Subject: UNABLE TO LOWER REAR SEATBACK WITH REMOTE HANDLE / SEATS HARD TO LOCK	Bulletin No: 09-013/13
	Last Issued: 04/29/2013

- This bulletin supersedes the previous bulletin 09-042/12, issued on 11/07/12. The APPLICABLE MODEL(S)/VINS and REPAIR PROCEDURE have been revised.
- Changes are noted below in Red beside the change bar.

2013-2014 CX-5 vehicles equipped with a 4:2:4 split type rear seat with VINs lower than JM3KE*****318331 (produced before Feb. 1, 2013)

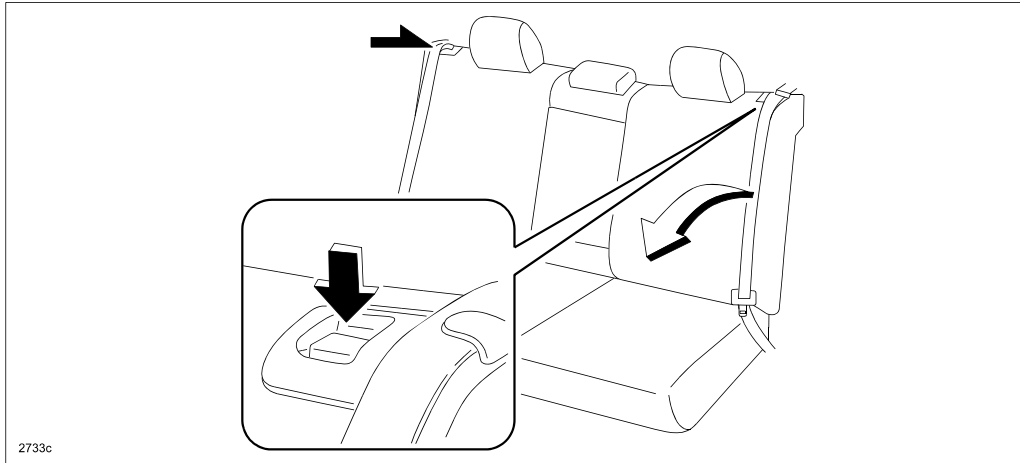
Some vehicles equipped with a 4:2:4 split type rear seat may be unable to lower the rear seatback (A) when pulling the left (B) and/or right (C) remote handles. Also, the seatbacks may not fully latch (lock) when placed in the upright position.

This concern may be caused by an incorrect seatback remote cable adjustment position. The current adjustment position may not provide enough tension for the cable to unlock the seatback latches.

The position of the seatback remote cable adjustment has been changed to the center position at mass-production.

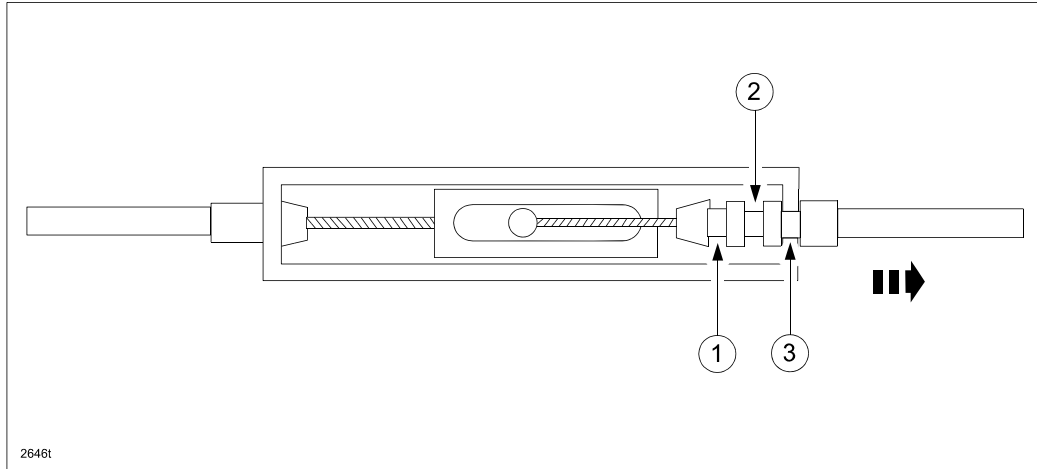
- Using a small flathead screwdriver, pop open the affected remote cable adjuster housing and check the current cable adjustment setting position (1, 2 or 3) as shown below.

NOTE: Cable adjustment setting position "3" is the factory setting for vehicle produced before **Feb. 1, 2013**.

- Pull the cable out of the housing and change the setting to position "2", then snap the remote cable adjuster housing closed.
- Using the appropriate remote handle lever, check the seat back for proper releasing and locking operation.
